# CITY OF ALBUQUERQUE

**Re: Shops @ the 24s  
32424 Louisiana Blvd NE  
Grading and Drainage Plan  
Engineer's Stamp dated: 8/14/2018 (H19D001)**

## DRAINAGE AND TRANSPORTATION INFORMATION SHEET (REV 6/2018)

# **The Shops @ the 24's Drainage Analysis Report**

SUB BASIN BOUNDARY EXHIBIT

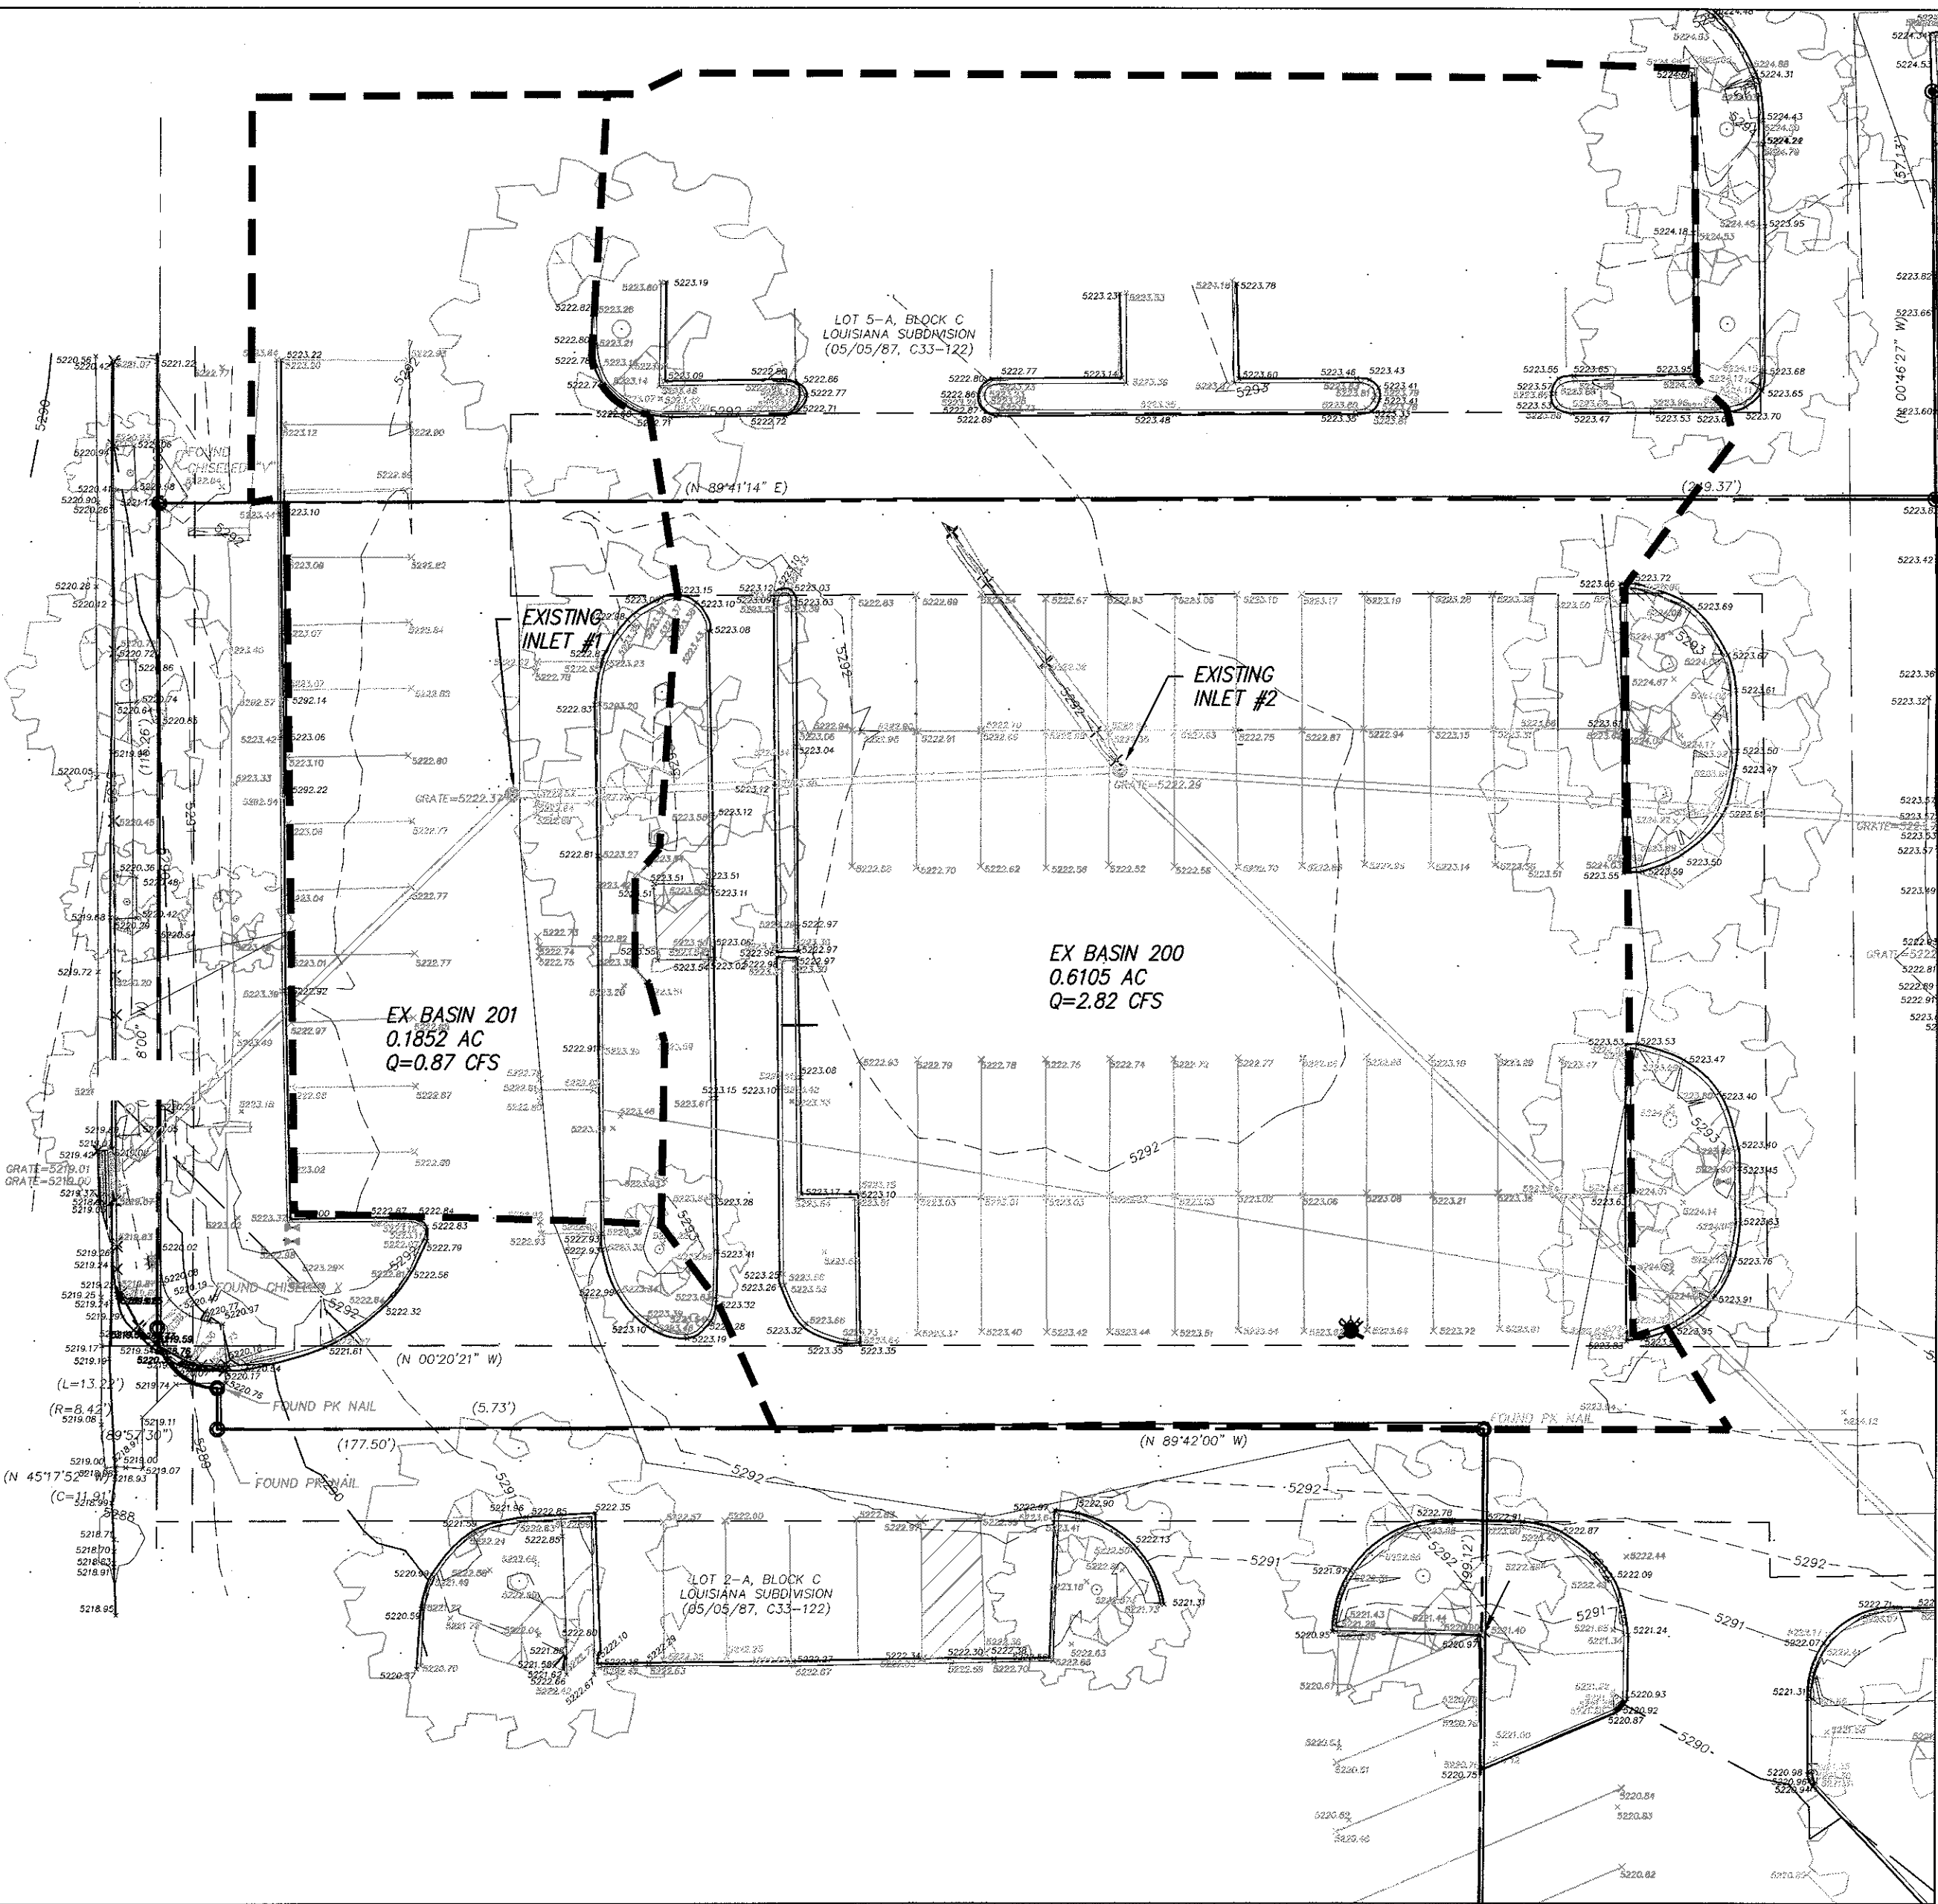
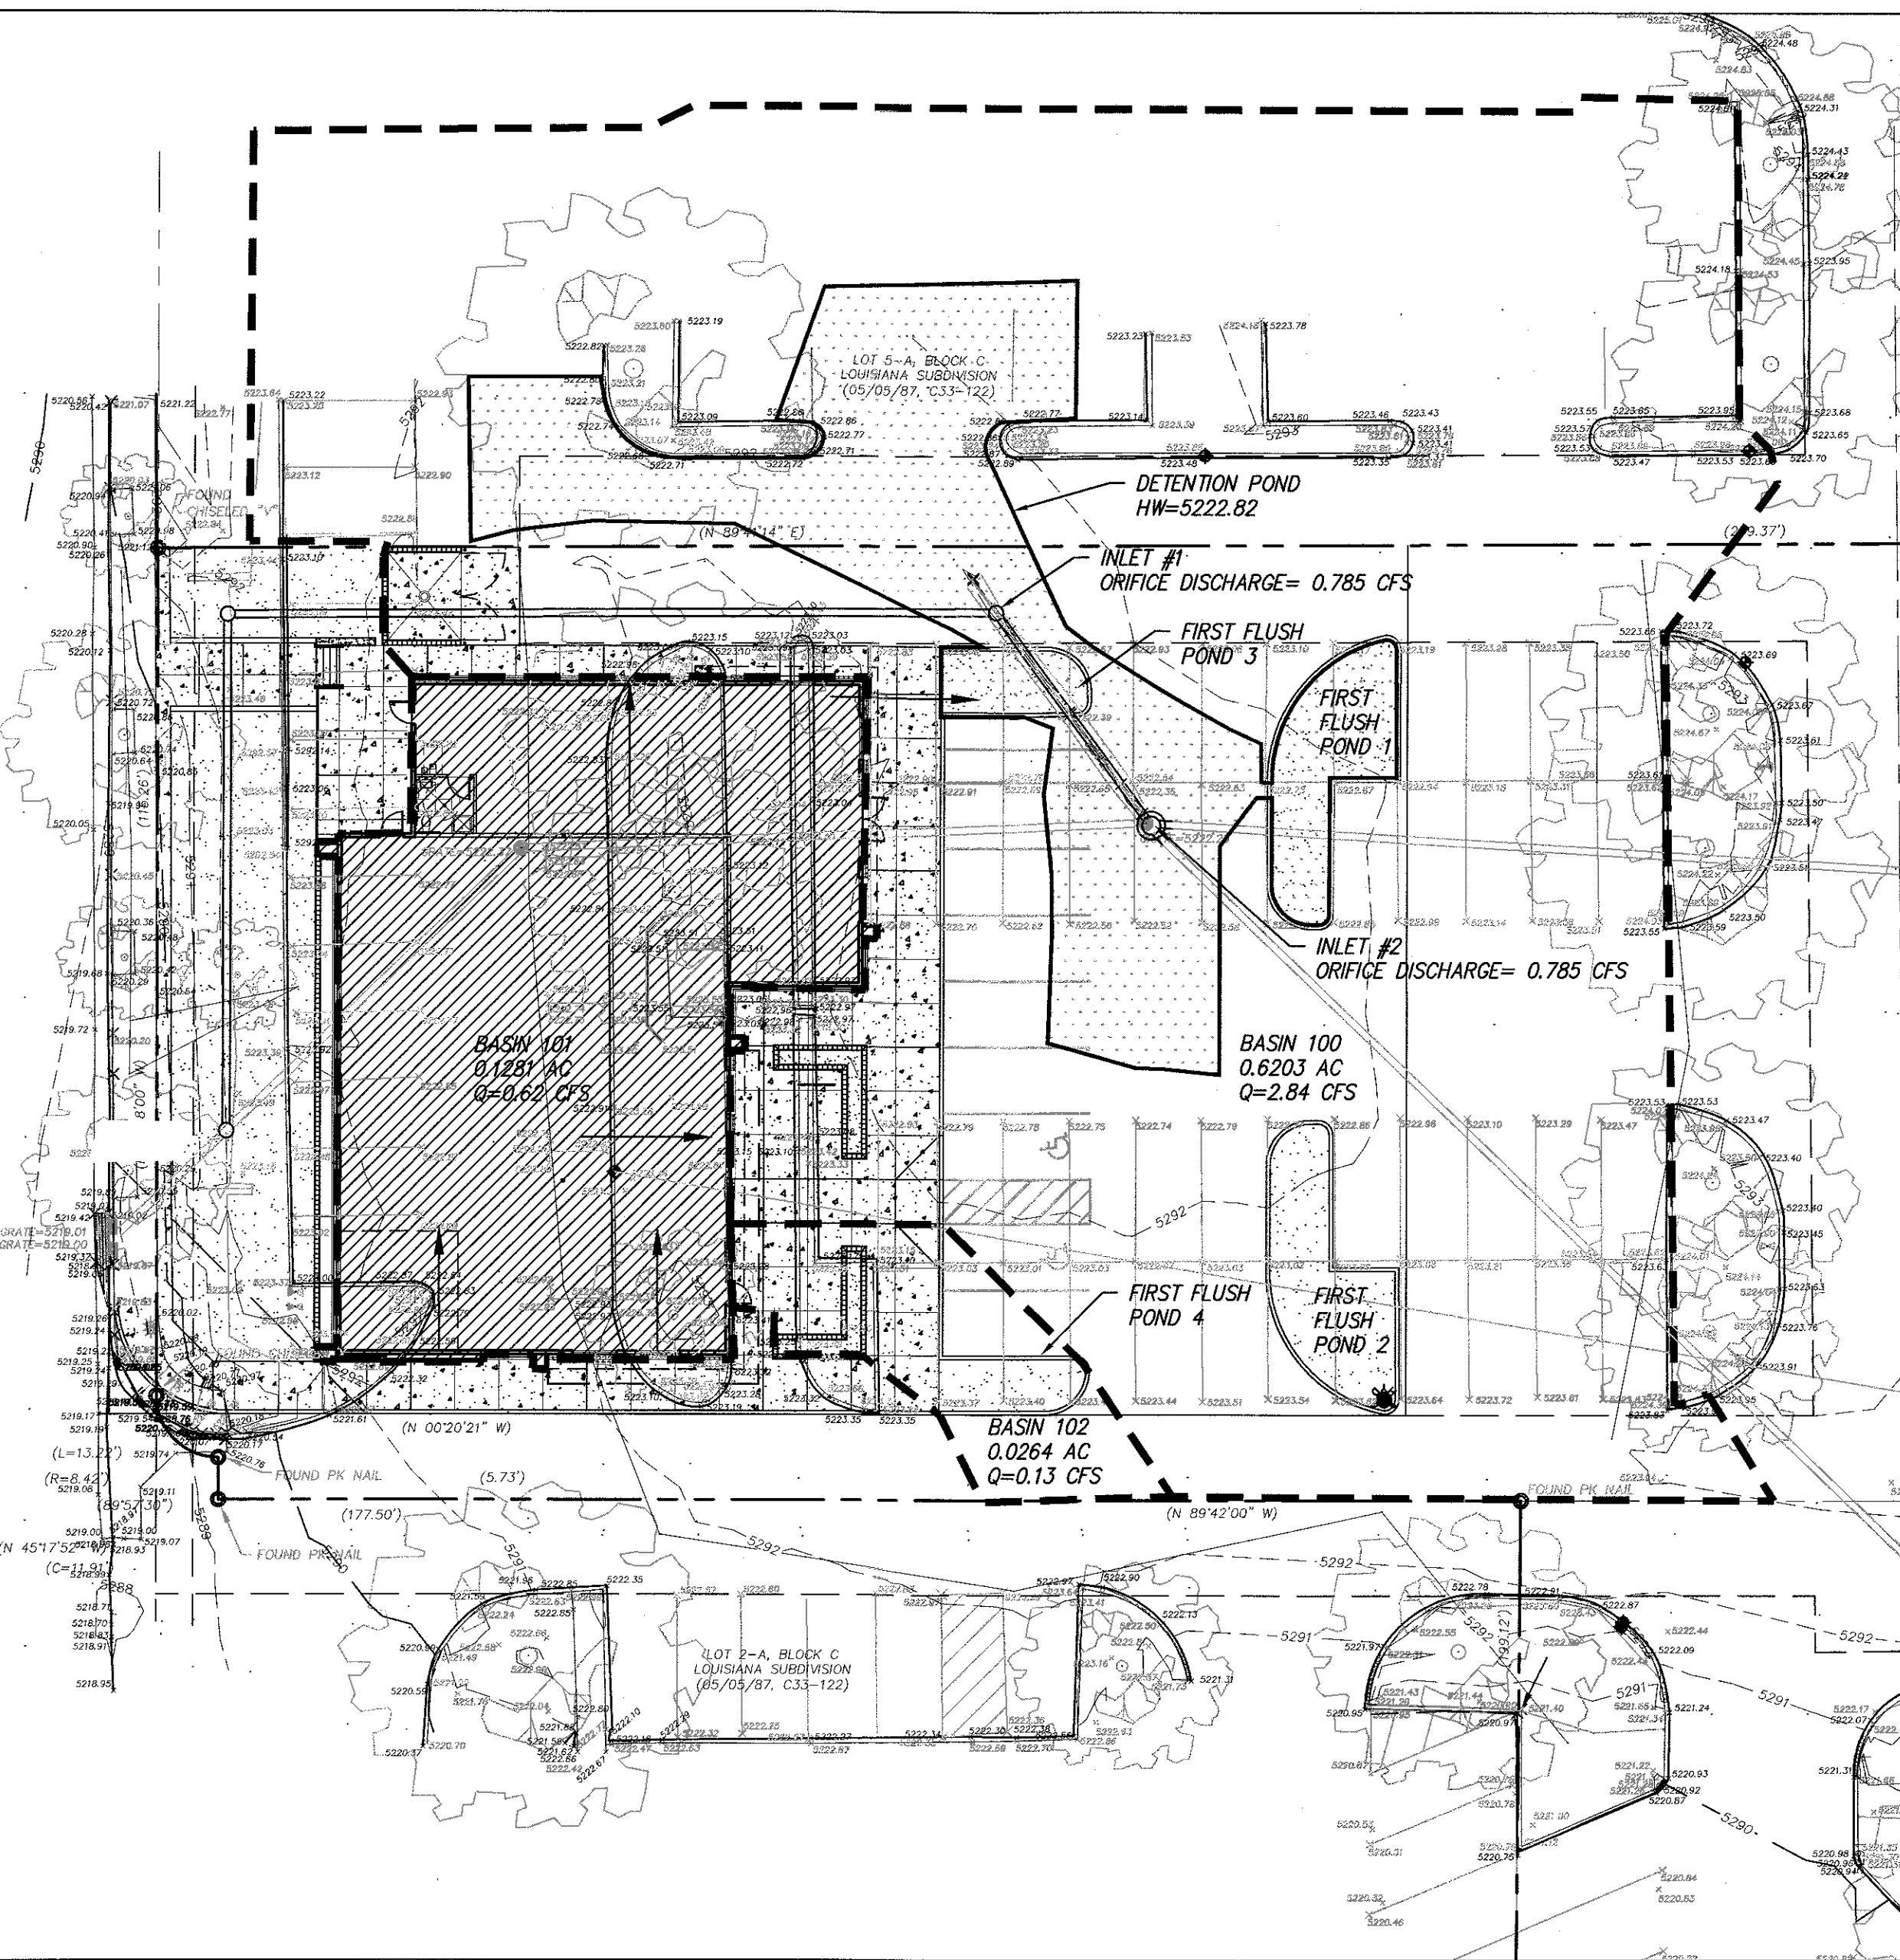
5. Additionally each first flush pond must be designed for the required volume of the area draining to it. The area draining to each first flush pond must be identified on the basin map. Calculations of the required volume and the provided volume must be presented on the plan and on the exhibits to be recorded with the maintenance covenant (multiple pages may be needed for clarity).

12. Clearly identify the area draining into first flush ponds 1, 3, & 4. What portion of the roof drains into each? Show contours and sections thru the edge of each pond and a section thru the spillway of each pond with weir calculations of 100 year elevation on the G&D Plan. Label both the 100 year and first flush elevation of each pond on the G&D Plan and on the Maintenance Covenant.
